R.W.C.D. 2 Extension

BID SCHEDULE NO. 1  
WILLIAMS-CHANDLER, WPP, ARIZONA  
RWCD FLOODWAY - REACH 2 EXTENSION

**PLAN & PROFILE FLOODWAY**  
 R.W.C.D. FLOODWAY-REACH 2 EXT.  
 WILLIAMS-CHANDLER W.P.P.  
 MARICOPA & PINAL COUNTIES, ARIZONA  
 U.S. DEPARTMENT OF AGRICULTURE  
 SOIL CONSERVATION SERVICE

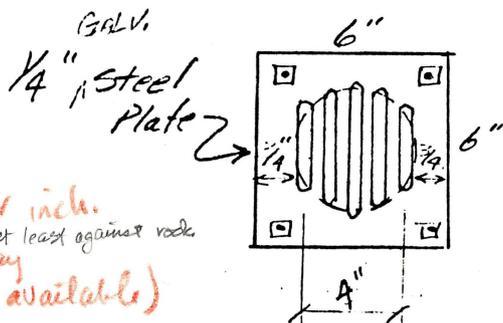
Suggest  
mesh screen  
as in concrete  
channel .8x.8 per inch.  
(calls for bronze - may  
not be commercially available)  
at least against rock

Rock riprap bedding (Reach 2)  
 $D_{10} = \#60 - \#146$  .25mm - 0.1mm  
Could have low perm rate

⇒ Use Drain Fill Gradation (R-2 Specs.)  
 $D_{85} \geq 7.5$  mm  
 $D_{10} 0.85 - 1.3$  mm

SECTION A-A

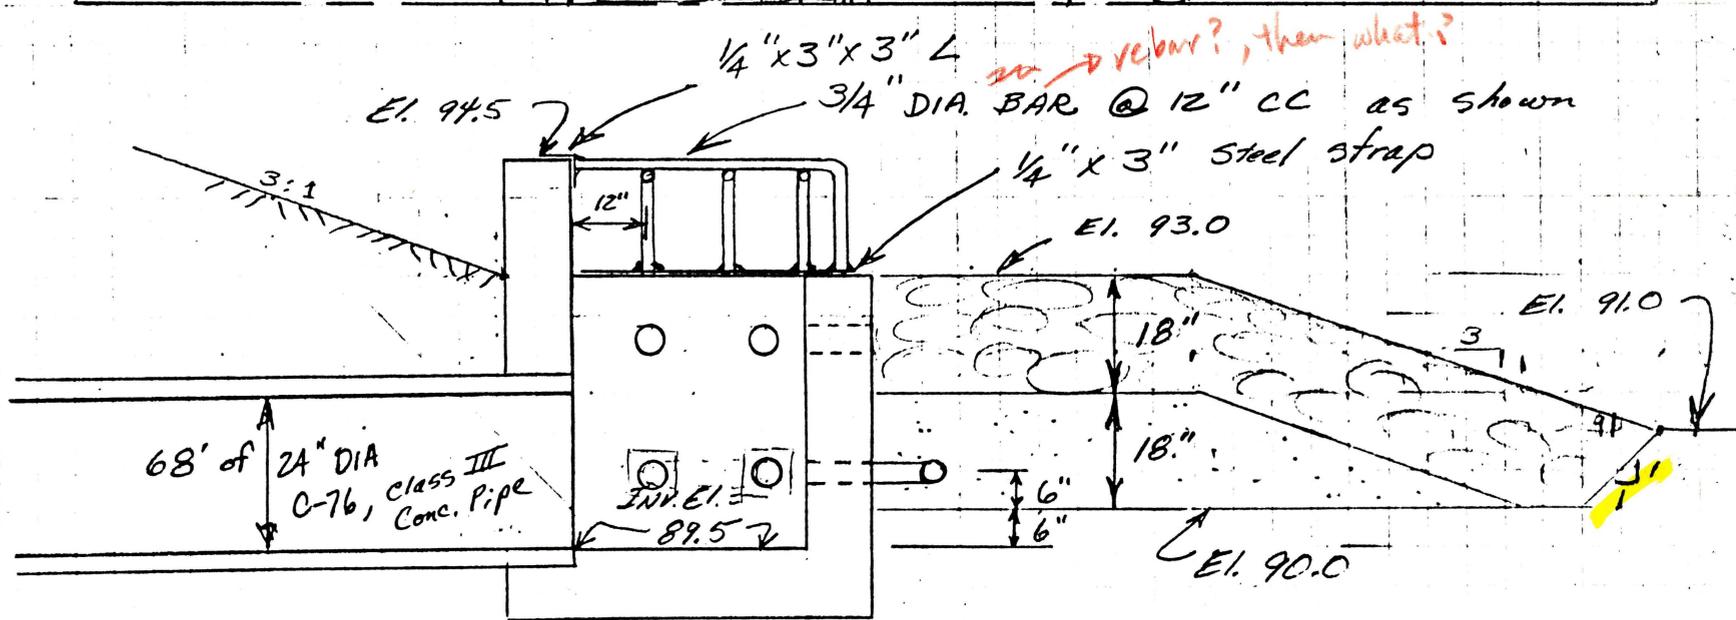
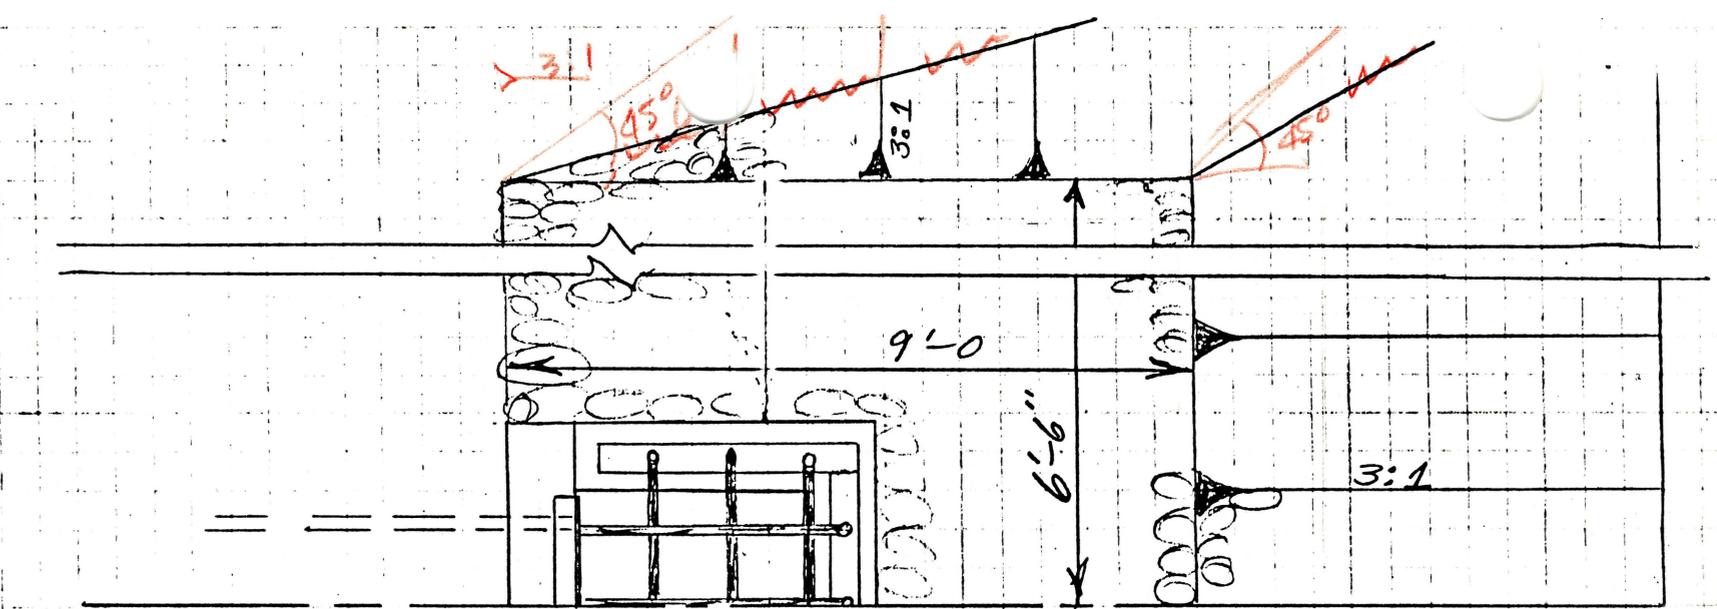
*Design: By inspection use  
 8" walls & Floor, #5 @ 12"  
 both directions, single grid.  
 LMS.*

*@ center of wall?*

AZ. RWCD R-2 Ext.  
LMS 3/83  
Side Inlet STA. 981+80 (Sediment Basin outlet)

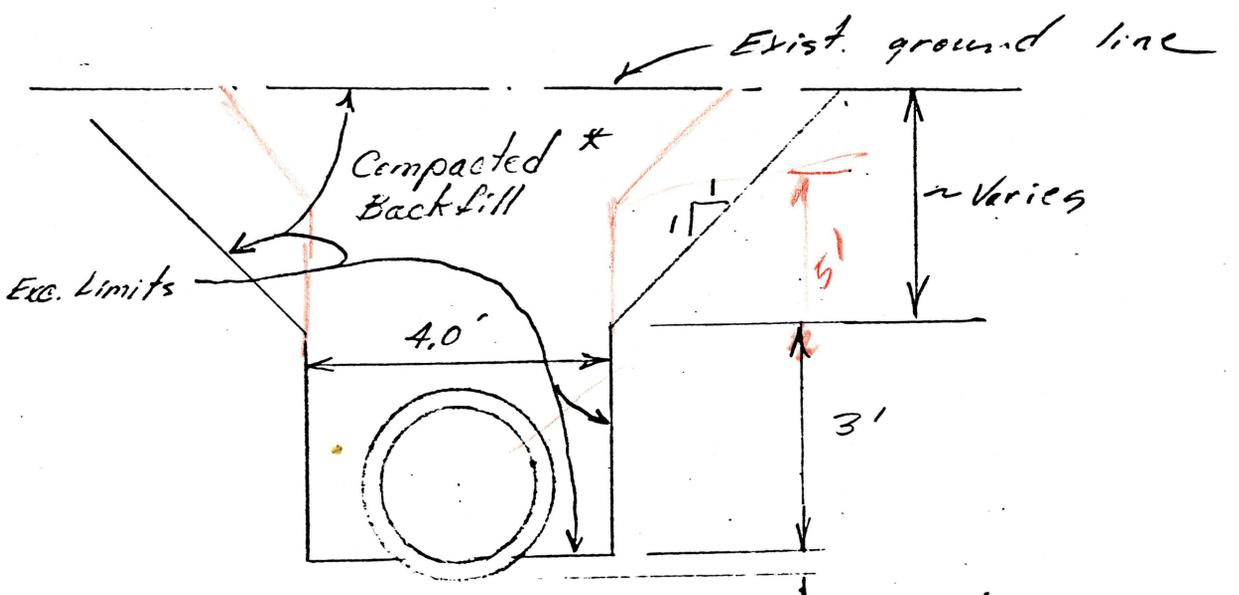
\* 90% of Std. D-698 within 3% of Opt. moisture.

3" min. Carefully shape bottom of trench to fit pipe use drainfill? or bedding?

A-A

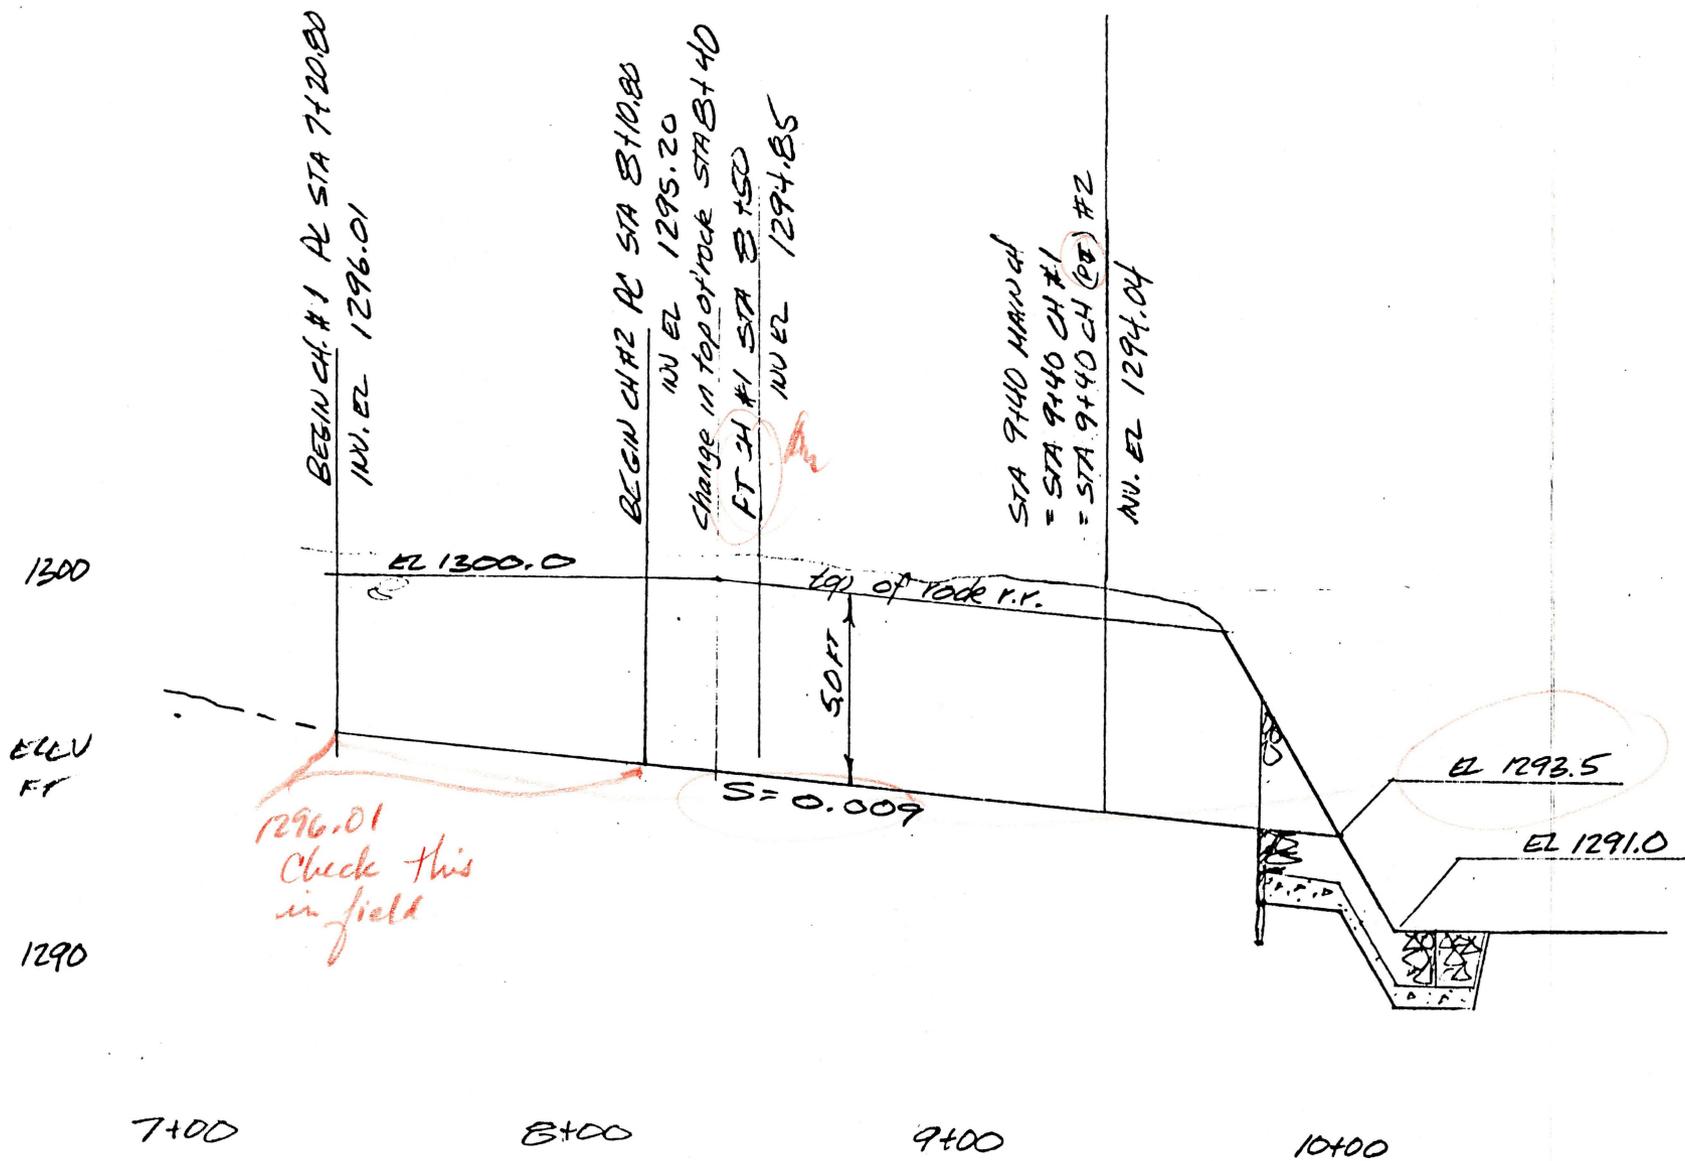
1296.01  
 Check this  
 in field

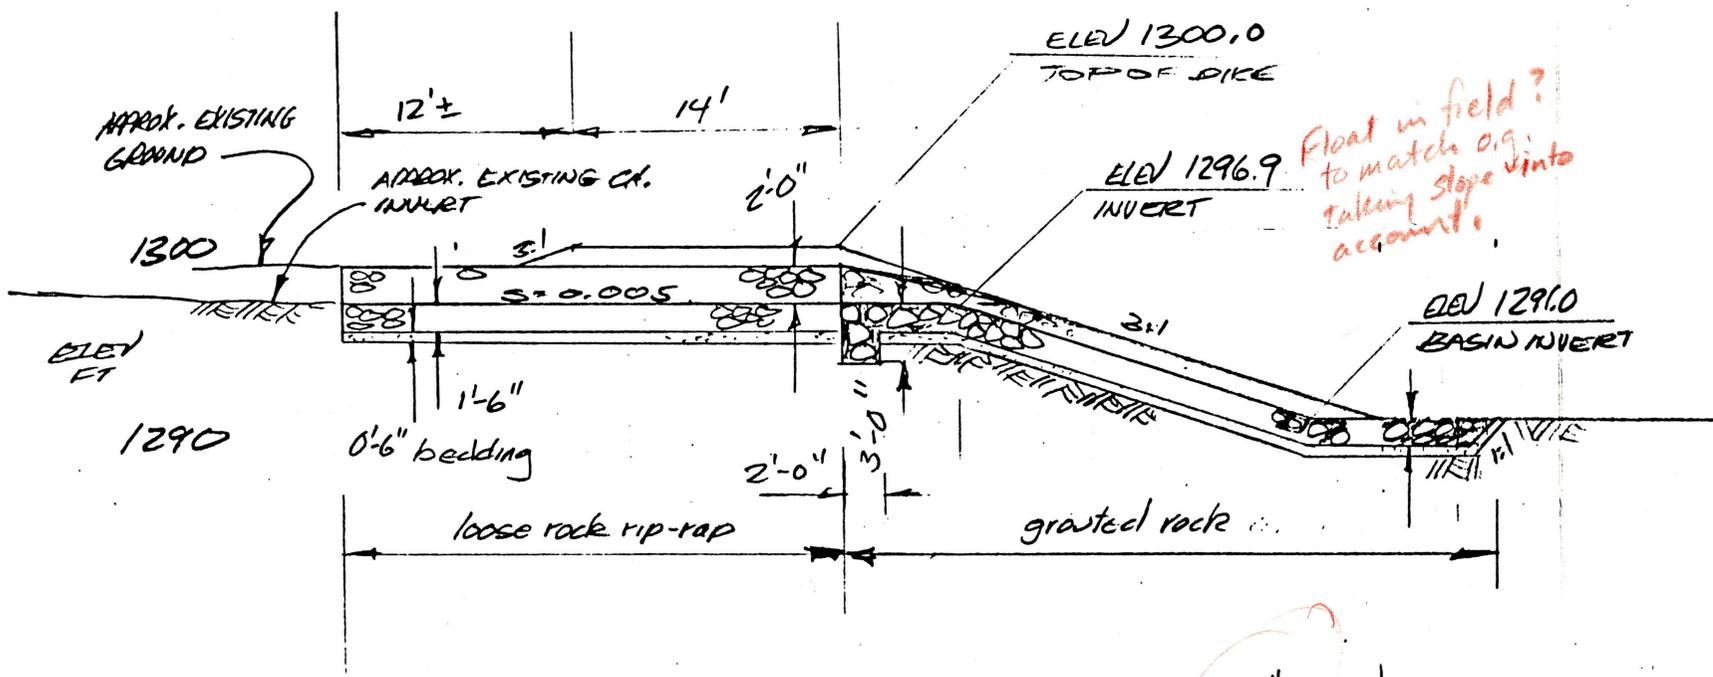
Float in field?  
to match orig.  
taking slope into  
account.

SECTION J-J RWCD ENTRANCE CHANNEL - RWCD STA 976+50  
LOOKING DOWNSTREAM

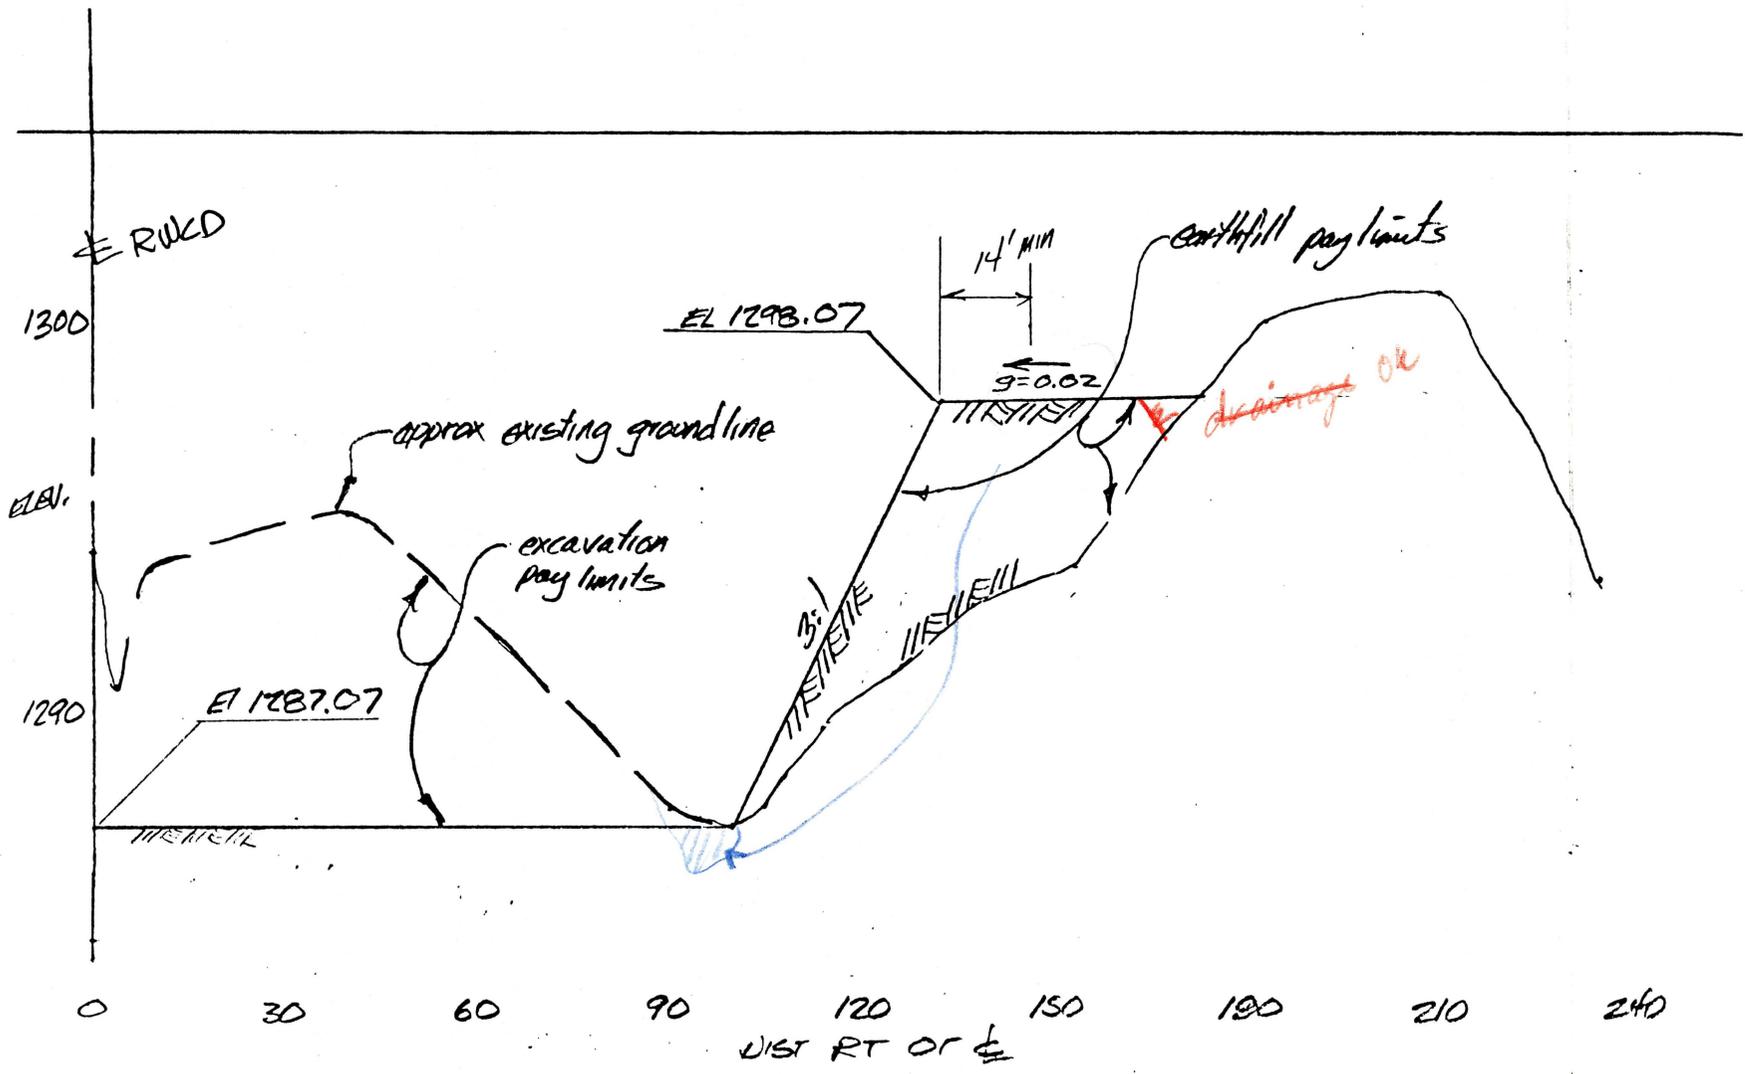
drainage  
Earth fill or  
match  
Existing  
will be hard to build

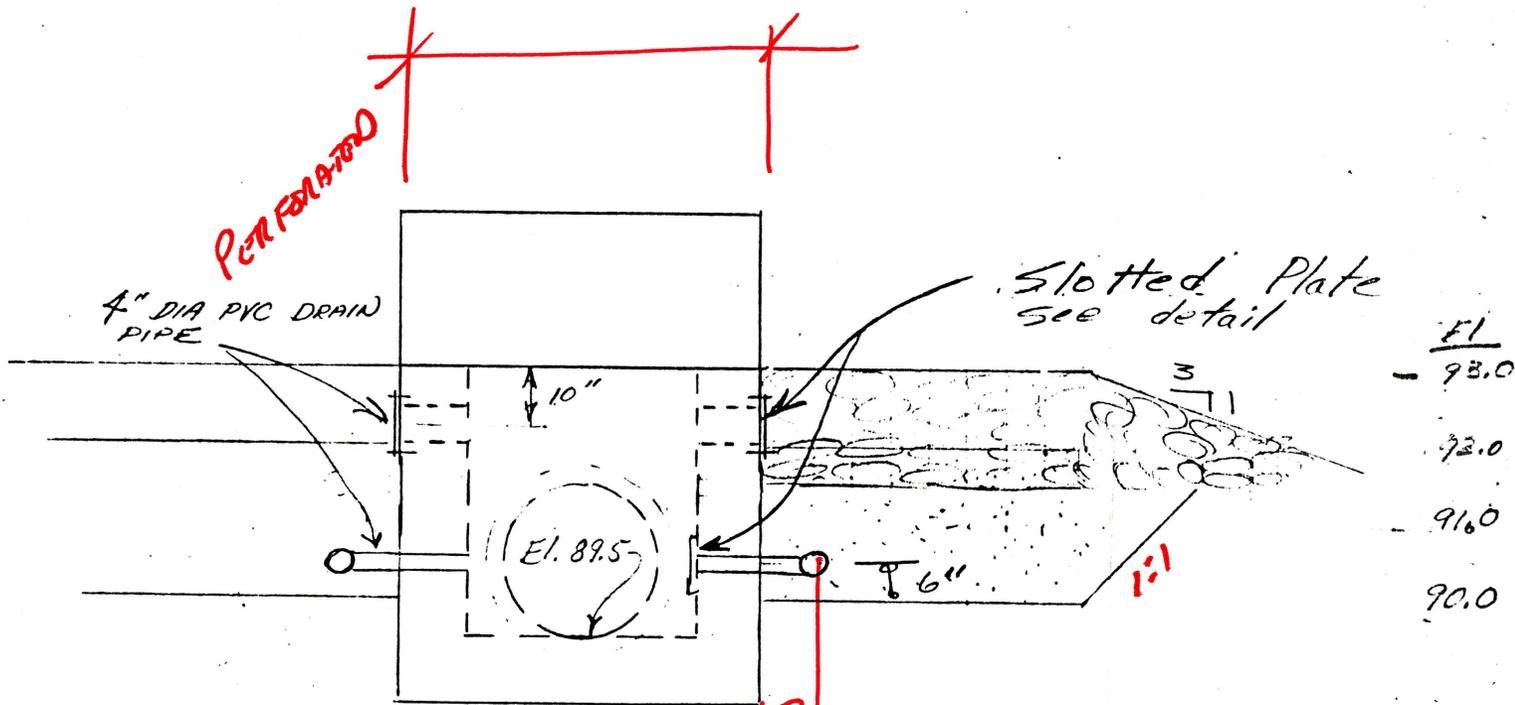
FASTENED?

⇒ Rock riprap  
Gradation used for Reach 2  
is satisfactory  $D_{100} \leq 15"$

Rock riprap bedding (Reach 2)  
 $D_{10} = \#60 - \#146$  .25 mm - 0.1 mm  
Could have low perm rate

⇒ Use Drain Fill Gradation (R-2 Specs.)  
 $D_{85} \geq 7.5$  mm  
 $D_{10} 0.85 - 1.3$  mm
